## **Town of Arlington, MA Redevelopment Board**

### **Agenda & Meeting Notice July 6, 2020**

##### **Docket #3602, 1207-1211 Mass Ave**

##### **Docket #3625, 882-892 Mass Ave**

PROPOSED HOTEL COMPLEX  
1211 Massachusetts Avenue  
Arlington, MA

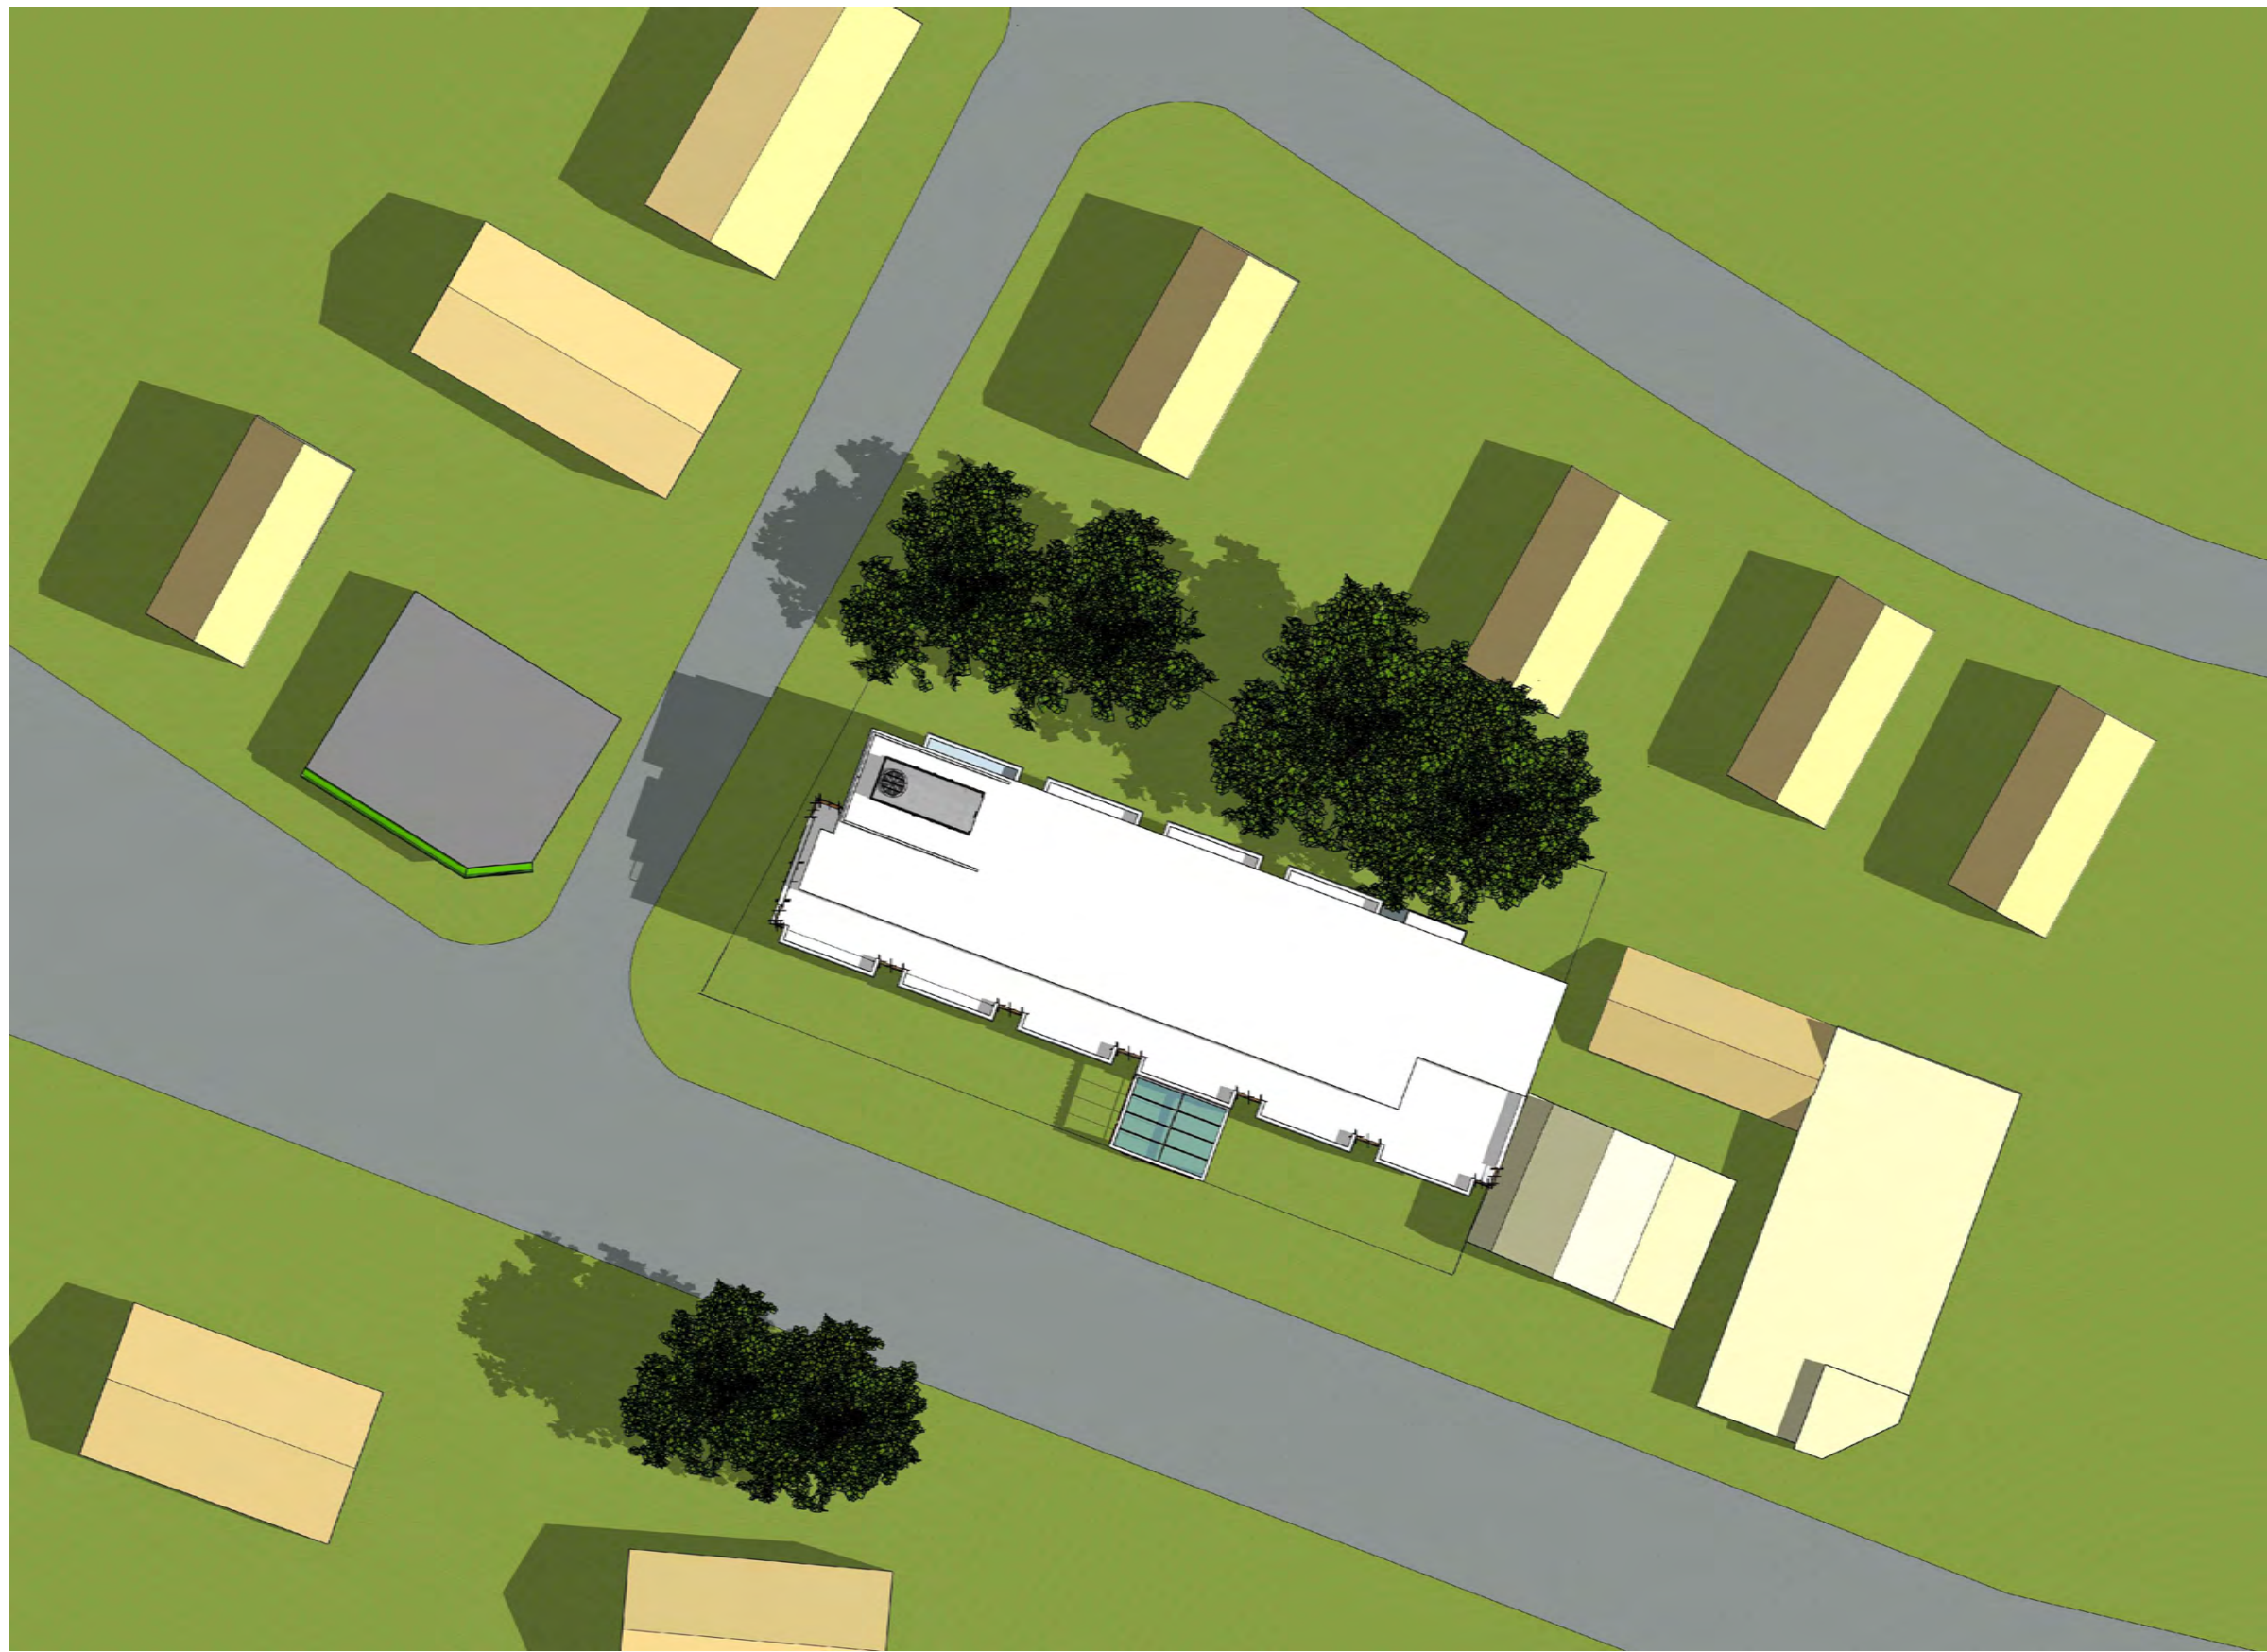
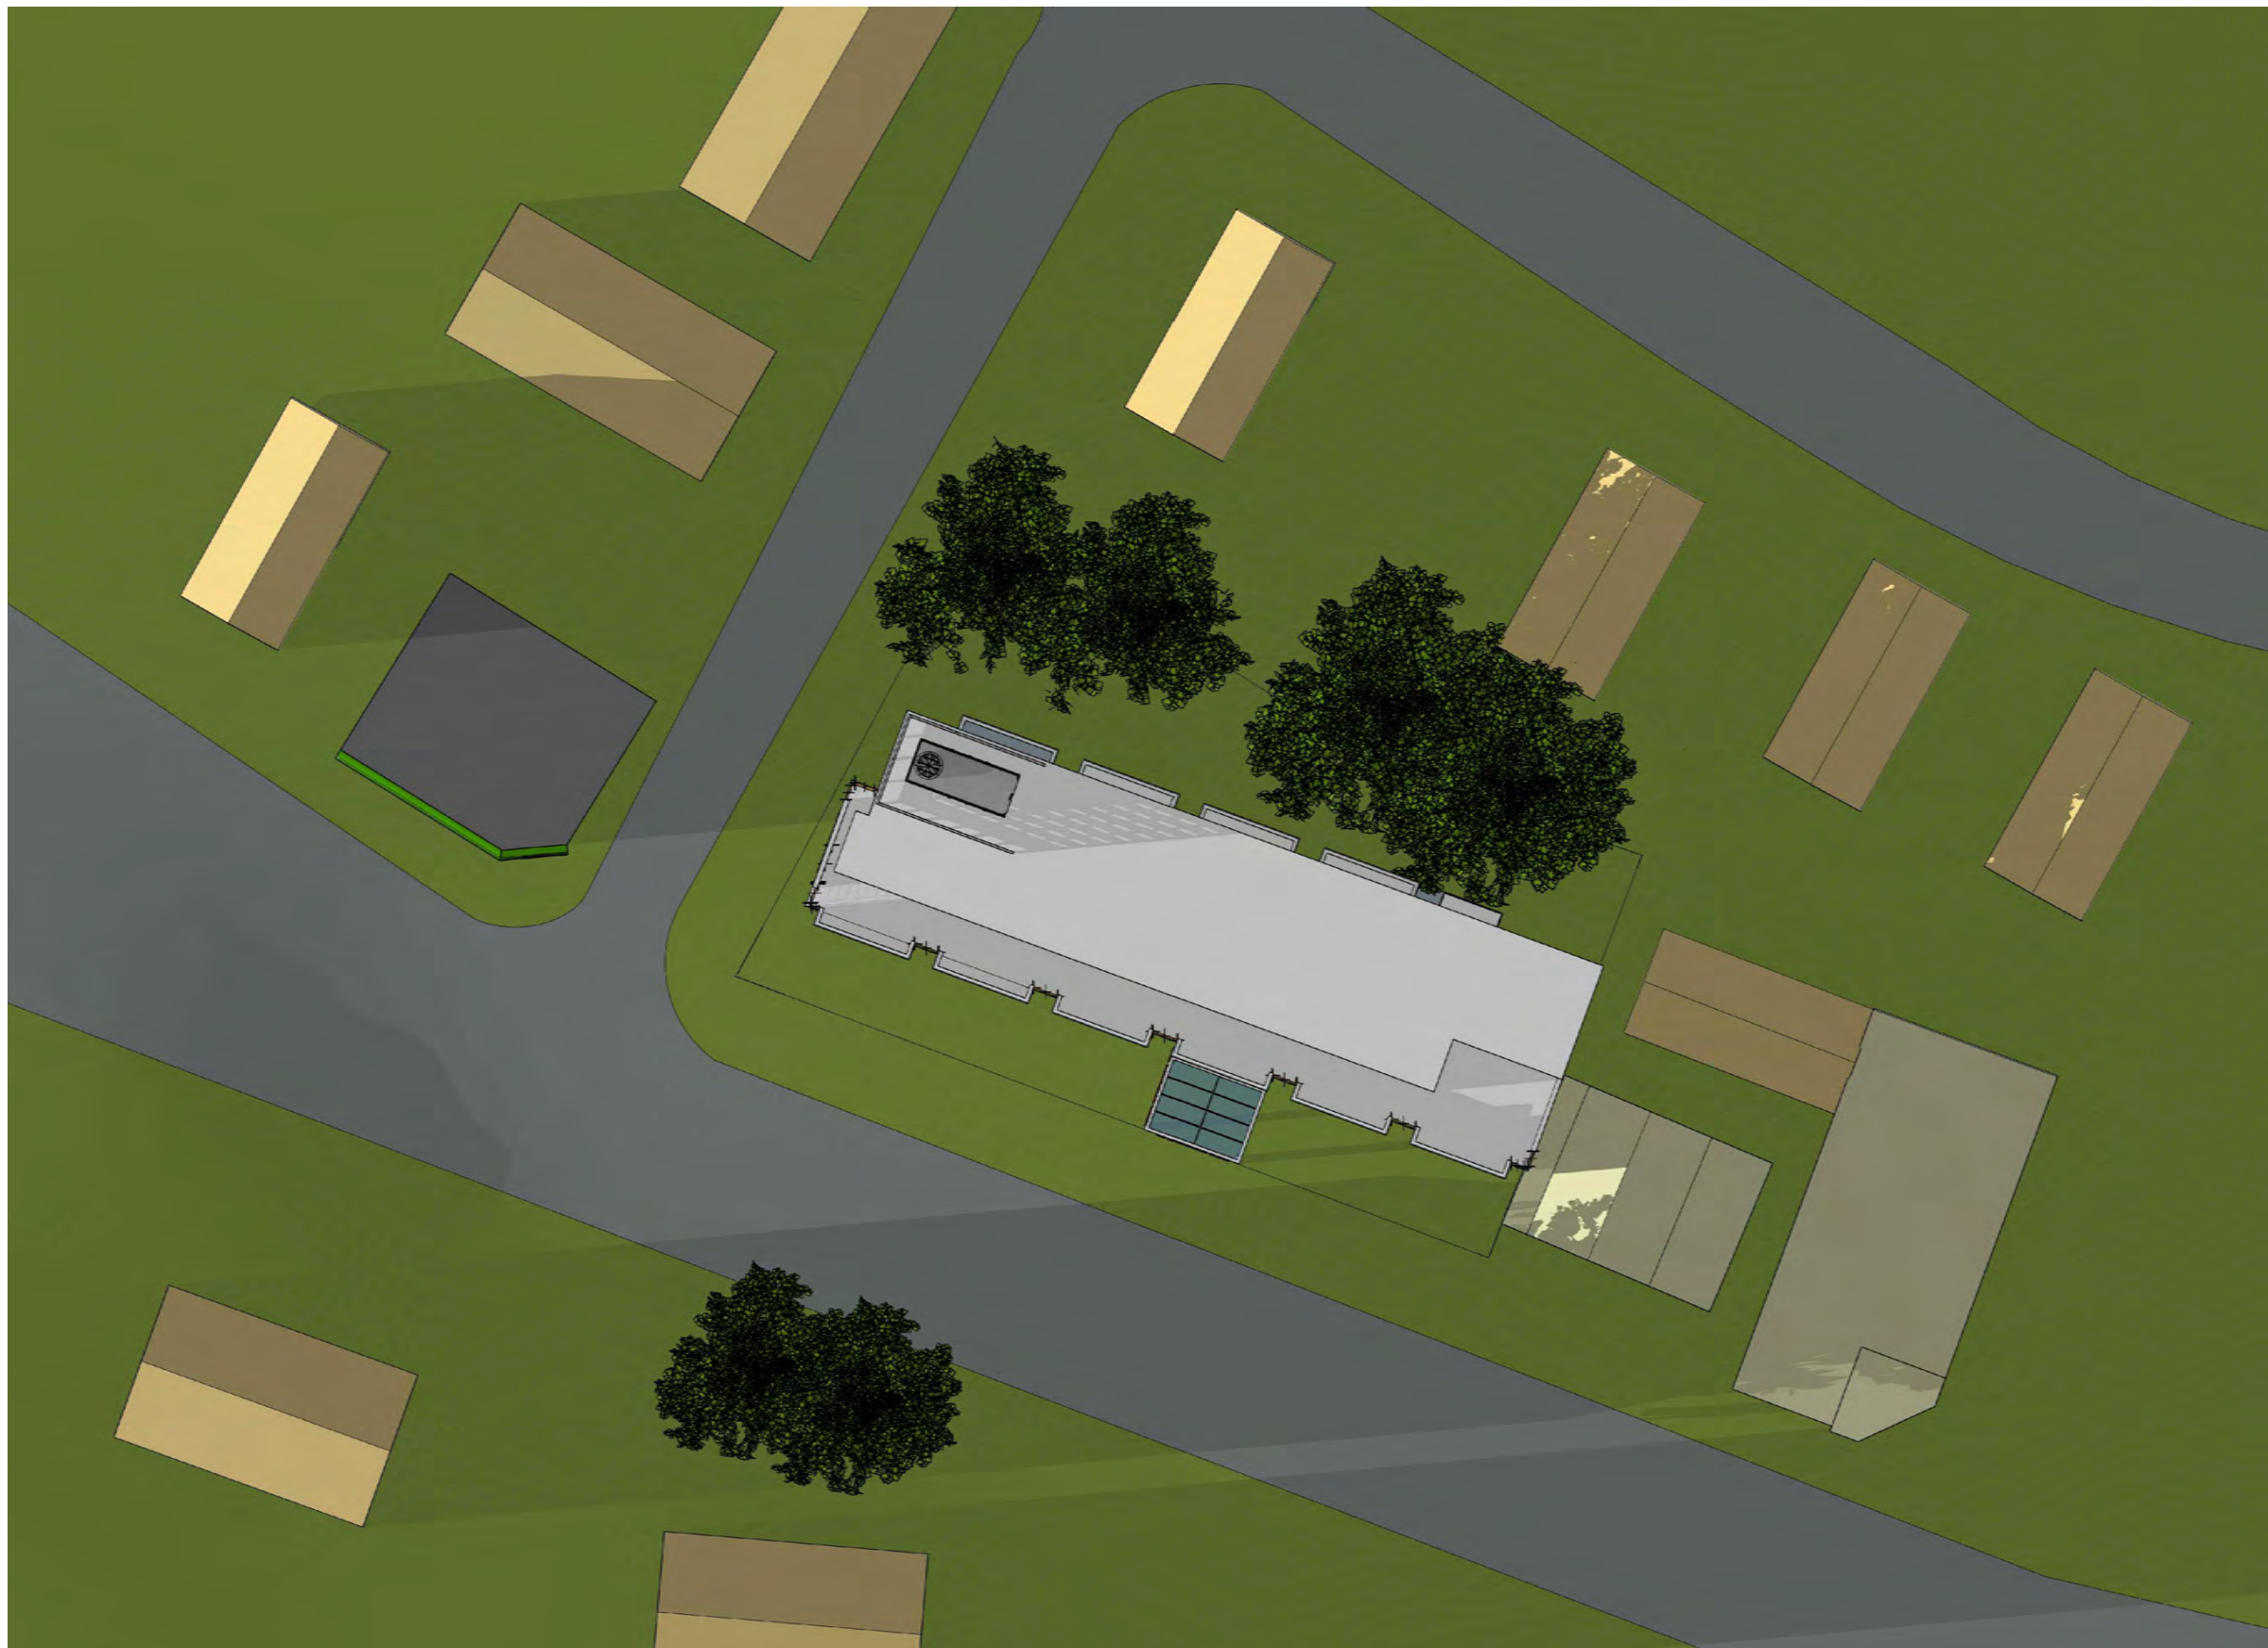
7. Re-evaluate the shadow study previously submitted to consider the existing shadows and provide a comparison and determine any impact to solar arrays in the neighborhood.

7. Take another look at your shadow study, consider the existing shadows and provide a comparison and determine any impact to solar arrays in the neighborhood;

*The plan set includes an updated shadow study based on the new building. The plan set also includes a shadow study documenting the existing conditions of the building and shows trees at the rear of the site.*

*The plan set includes an updated shadow study based on the new building. The plan set also includes a shadow study documenting the existing conditions of the building and shows trees at the rear of the site. The updated materials do not identify if any of the adjacent buildings have solar arrays installed.*
